# SERVICE BULLETIN

M-1224

Safety Recall Code 0135

## 2008 Touring Fuel Filter Shell Recall

Figure 1. Fuel Tank Top Plate

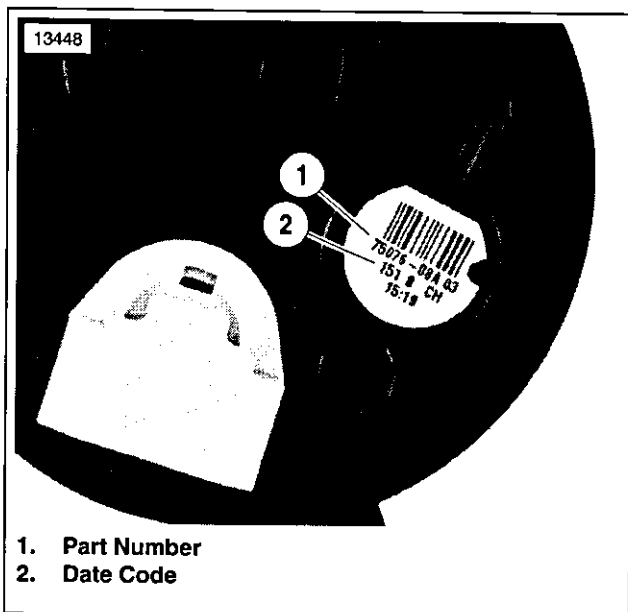
- See Figure 1. Remove dash housing/center console. See FUEL TANK TOP PLATE in the Touring Models Service Manual.
- Inspect decal with part number and date code on fuel tank top plate.
  - If part number (1) is 75069-08A or 75076-08A, then install dash housing/center console. No replacement is required.
  - If part number (1) is 75069-08 or 75076-08 with a date code (2) of 267 7 (267<sup>th</sup> day of 2007) or later, then install dash housing/center console. No replacement is required.
  - If the part number is 75069-08 or 75076-08 and has a date code earlier than 267 7, continue disassembly to replace the fuel filter shell using the new filter shell and o-ring provided in the kit.

- Remove fuel filter shell. See FUEL FILTER in the 2008 Touring Models Service Manual.
- Remove fuel filter and fuel pressure regulator and install on new fuel filter shell (included in kit.) See FUEL PRESSURE REGULATOR in the 2008 Touring Models Service Manual.
- Carefully remove fuel line retainers and install on new fuel filter shell. See FUEL TANK TOP PLATE in the Touring Models Service Manual.
- Install new fuel filter shell with new o-ring (included in kit). See FUEL FILTER in the 2008 Touring Models Service Manual.
